July 15, 2013

**Subject: Turners Falls Hydroelectric Project, FERC Project No. 1889
Northfield Mountain Pumped Storage Project, FERC Project No. 2485
Comments on Proposed Study Plan**

Figure A: Example of a spatial map that may be created using PHABSIM (from Milhous and Waddle 2012).

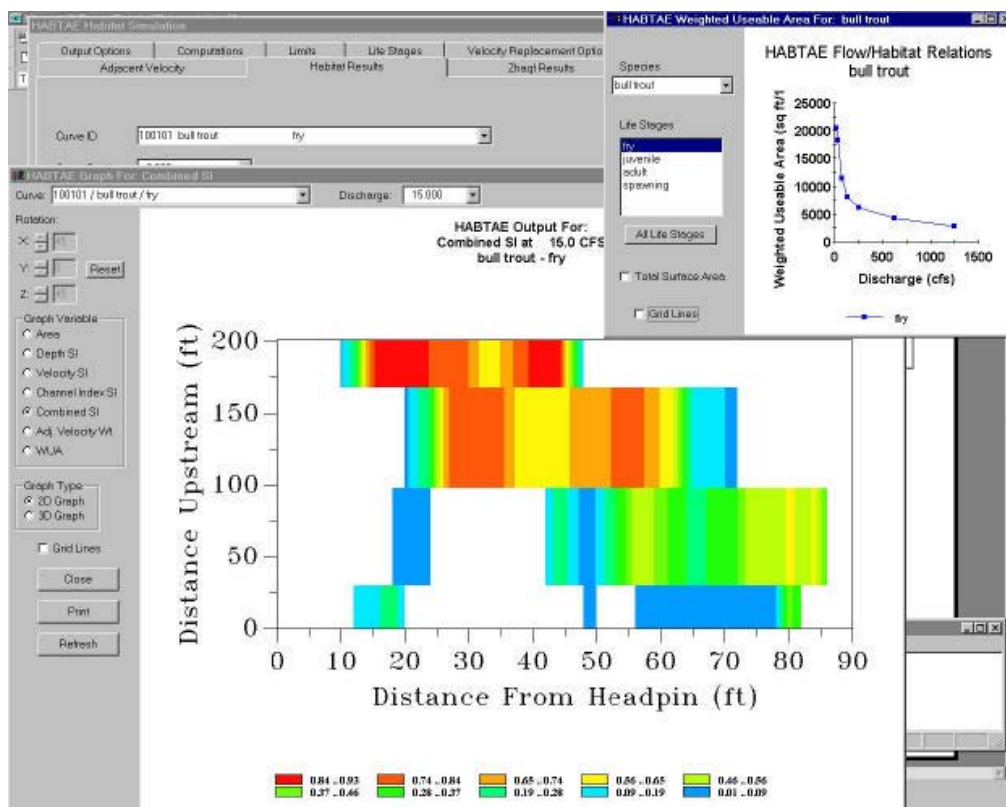
In previous comments to FirstLight, we recommended the inclusion of spatial maps that depict weighted usable area (WUA) across cells and over a range of flow values (Figure A) for all sites for which 1D analysis is conducted. We recognize the excessiveness of doing this for all habitat criteria of all life history stages and species being evaluated in this study. However, there is still high value in understanding how spatial habitat patterns change over a range of flow. As a compromise, we suggest the inclusion of these spatial maps at least for the habitat guild criteria (i.e., shallow-fast, shallow-slow, deep-fast habitats). This would give a basic understanding of the dynamic spatial patterns of habitat in the study area without excessive effort.
